ADDENDUM TO MC68349 Dragon 1 High Processor User's Manua May 5, 1995

This addendum to the initial release of the MC6834 text, plus additional information not included in the or is maintained on the AESOP BBS, which can be I (512)891-3650. Configure modem for up to 14.4Kt should support VT100 emulation. Internet acce [129.38.233.1] or through the World Wide Web at ht

Case 86

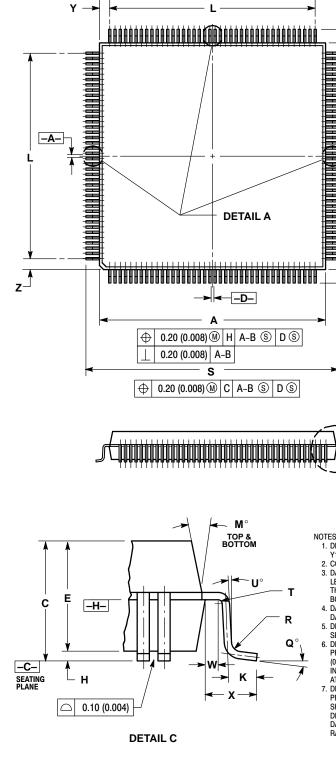
The package dimension drawing on page 12-4 should b
